REQUEST

Current Zoning: R-5 (single family residential)
Proposed Zoning: UR-2(CD) (urban residential, conditional)

Approximately 0.37 acres located at the southwest intersection of Parkwood Avenue and Harrill Street, east of Seigle Avenue.

The petition proposes to allow a single family attached (townhome) development with up to nine residential units on a parcel currently developed with a single family residence.

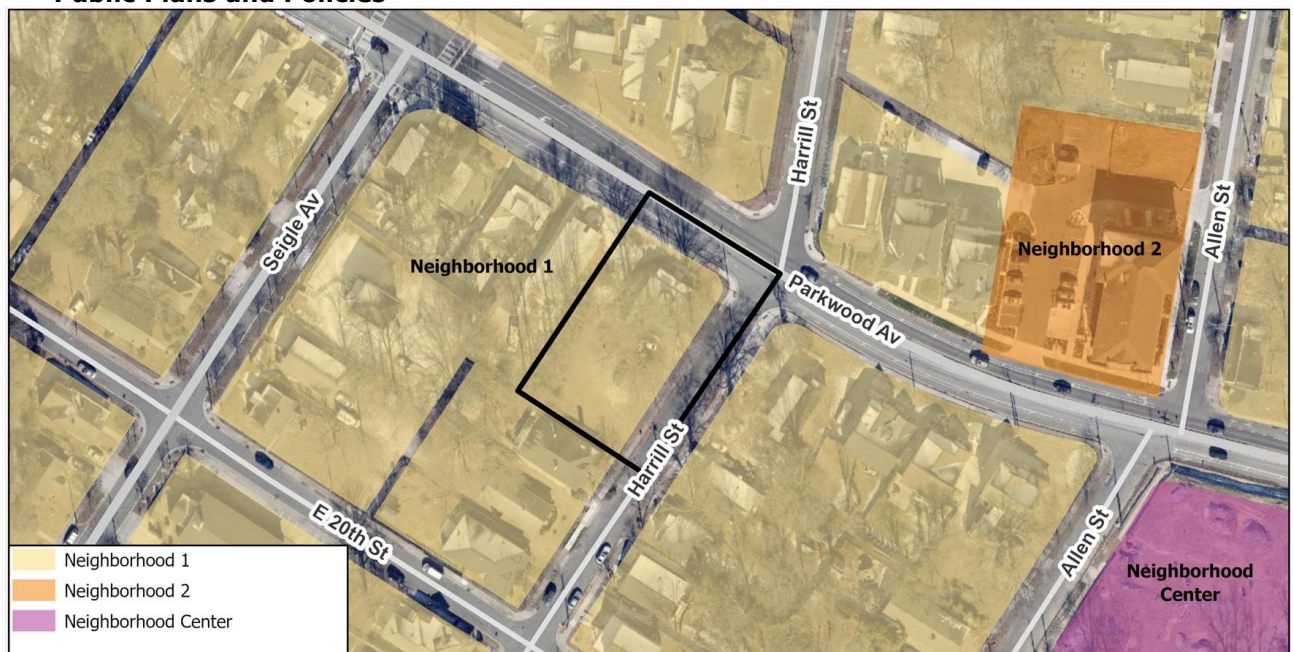
- ~~1. Curblin~~ The proposed zoning district has a setback measured from back of the existing or proposed future curblin.
 - ~~a. Parkwood Avenue: Future back of curb and gutter to be placed 27 feet from Parkwood Avenue road centerline.~~ Addressed
 - ~~b. Label and dimension the curb and gutter from the centerline for each road on the site plan.~~ Addressed
- ~~2. Label and dimension existing curblin measured from centerline of Parkwood Avenue. Show existing buffered bike lane (with dimensions) along Parkwood Avenue for CDOT to determine if existing conditions are to remain.~~ Addressed
- ~~3. Site plan and conditional note(s) revisions are needed to commit to construct bicycle facilities by locating the curb and gutter 27 feet from the Parkwood Avenue road centerline and installing an 8 foot buffered bike lane along Parkwood Avenue to meet the City Charlotte BIKE Policy.~~ Addressed

-
4. ~~A site plan note(s) specifying dedication and fee simple conveyance of all rights of way to the City before the site's first building certificate of occupancy is issued as needed. CDOT requests rights of way set at 2' behind back of sidewalk where feasible.~~ Addressed
 5. ~~Update conditional note to include a 2' sidewalk utility easement (SUE) instead of 1' to match site plan.~~ Addressed

6. ~~Tree save must be comprised of existing trees. If replanted tree save must be done at 150%. Area shown on plan does not have existing trees. More tree save than what is shown would be required.~~ Addressed

7. ~~Provide more clear architectural details on how Building 5 will interact with Harrill St. Need to define treating portions of the building as a front versus a side through things like a wrapped porch, door placement, or other design elements.~~ Addressed
